UNITED STATES PATENT AND TRADEMARK OFFICE

10/517,196

Office Action Summary	Application No. 10/517,196	Applicant(s) ROMMEL, CHRISTIAN	
	Examiner JAMES R. BRITTAI	Art Unit 3677

DETAILED ACTION

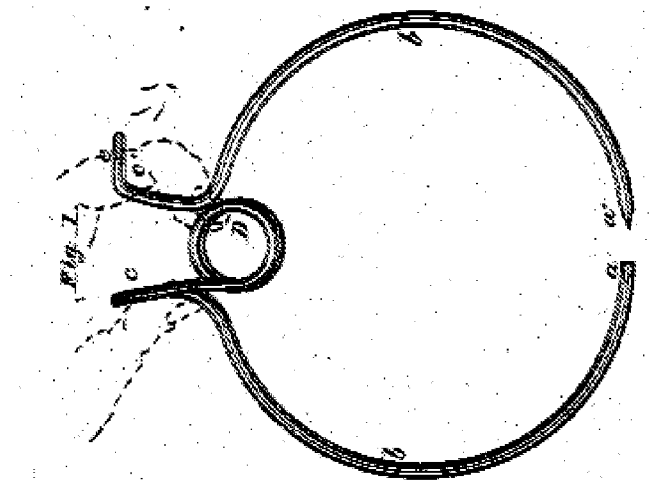
Crandell (figures 1, 2) teaches a holder inherently capable of holding sample cards having eyelets therein comprising two holding bodies, b, b', forming a ring-like configuration, two handgrips, c, c', with one having an eye, e, acting as a hanging device for the holder, a spring loaded pivoted joint, D.

FIG. I.

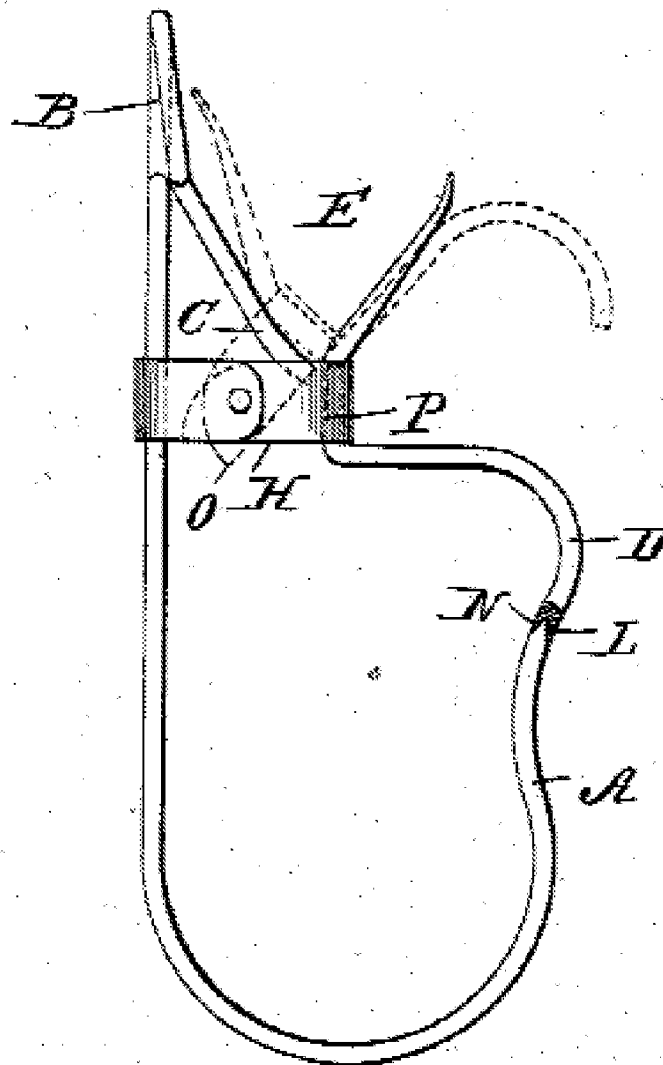
Keep (figure 1) teaches a holder inherently capable of holding sample cards having eyelets therein comprising two holding bodies, A, D, forming a ring-like configuration, two handgrips, B, E, with one, B, having an eye fully capable of being a hanging device for the holder, a spring, C, loaded pivoted joint, H, and beveled end faces, N, L, on the holding bodies.

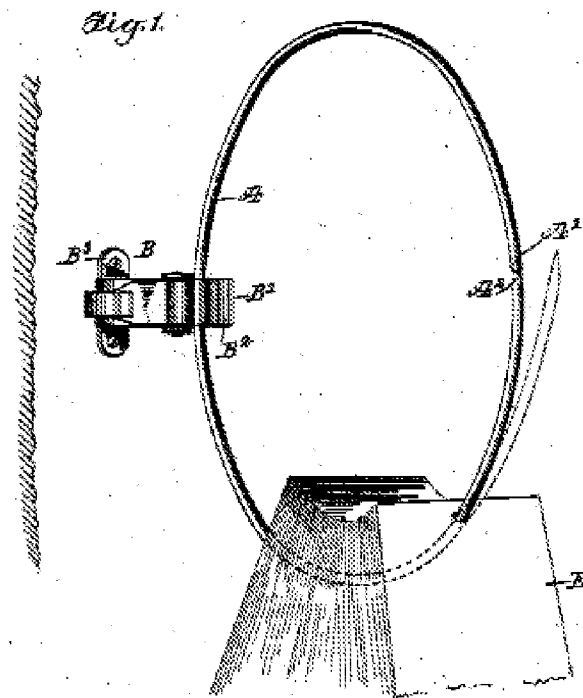
The difference is that the holding bodies don't form an oval. However, Stebbings (figure 1) provides ample evidence that it is old and well known to form an oval holder (page 1, lines 70-74).

Therefore, it would have been obvious for the holding bodies of the devices of either Crandell or Keep to form an oval in view of Stebbings (figure 1) teaching that it is old and well known to form an oval holder (page 1, lines 70-74).
